## SERVICE BULLETIN #54A

DATE: April 3rd, 2001

SUBJECT: 912ULS and 912UL Engine installations.

APPLICABILITY: All Kitfoxes using 912ULS and 912UL Engine Installation Kits shipped prior to May of 2001

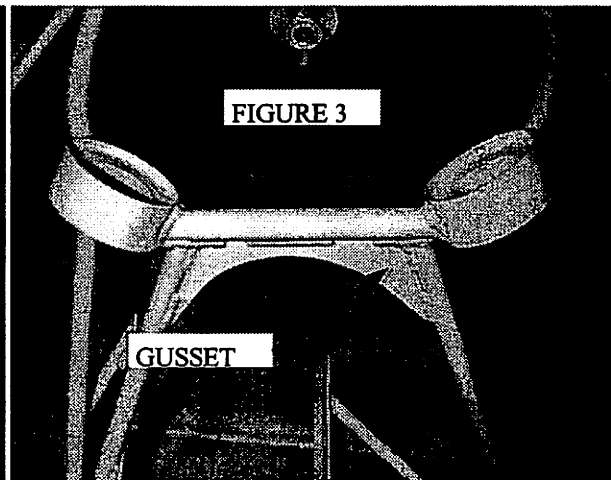
1. Shorten the engine mount isolator bushings, P/N: 41501.000 to an overall length of .93". See figure 1.
2. Replace engine mount isolators, P/N: 44023.000 and P/N: 44024.000 on an annual bases.

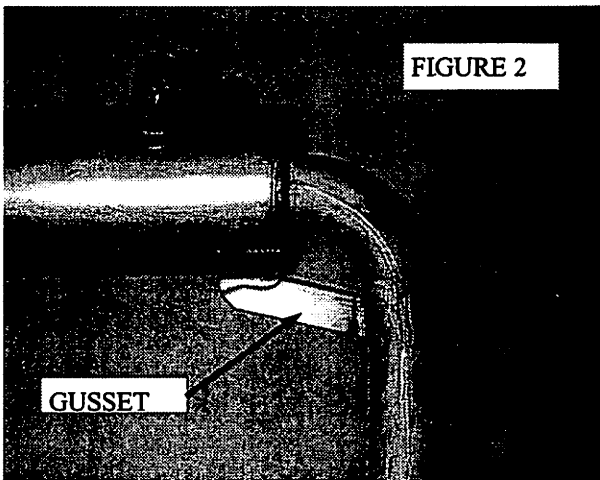
3. Inspect your exhaust system for cracks. Check all welds, header tube junctions, and stinger for cracks. If your Muffler does not have the gusset as shown in figure 2 then the muffler will need to be sent to SkyStar for the gusset installation. Any cracks found need to be repaired or replaced before next flight. See return policy at the end of this bulletin. Check the stinger outlet hole clearance in the cowling. You should have a minimum of 1/2" clearance between the cowling and the stinger to prevent failure of the stinger.

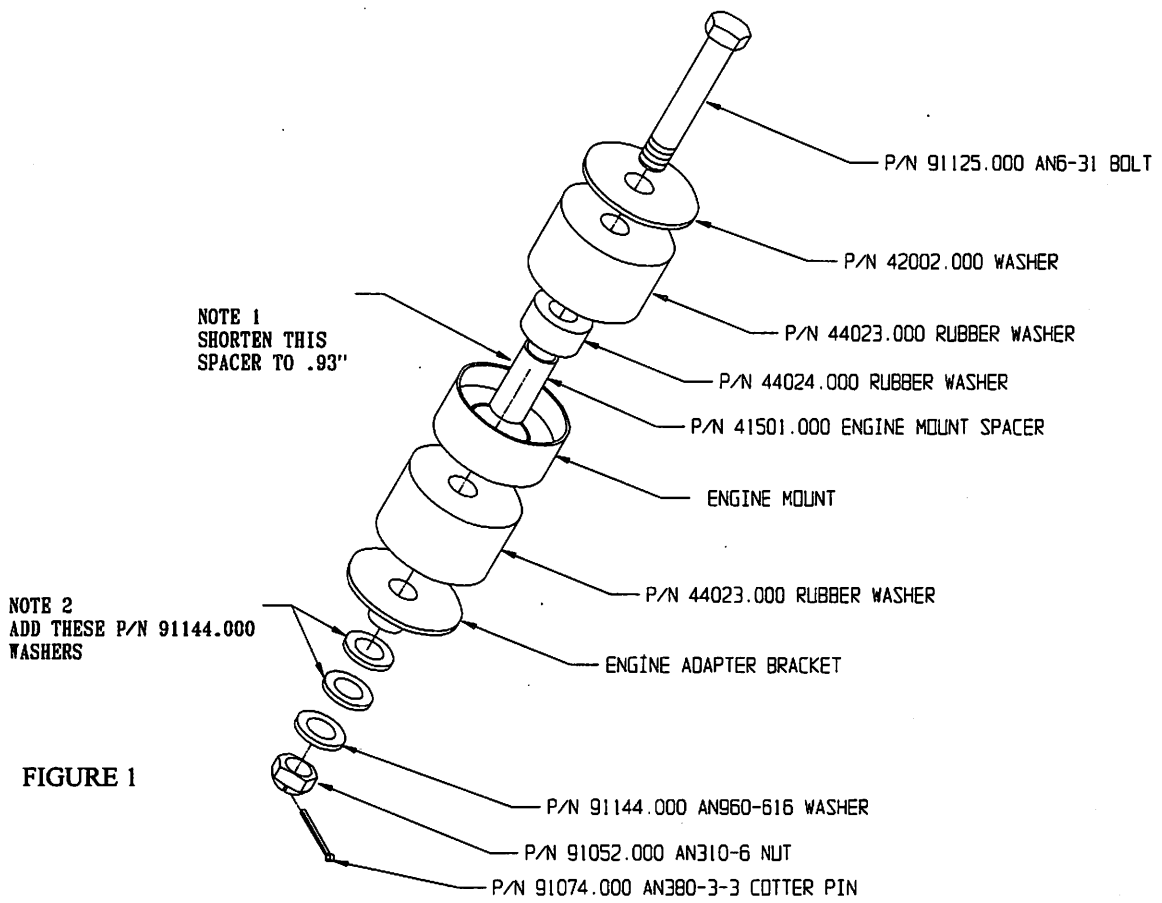
4. Inspect engine mount. Check the engine mount for cracks. Report any cracks found to SkyStar Technical Support. For Kitfox Model 1 through 4 owners that have upgraded from a 912UL to a 912ULS check your engine mount for the gusset shown in figure 3. If the gusset is not present then you will need to purchase an updated engine mount or have your engine mount updated by SkyStar.
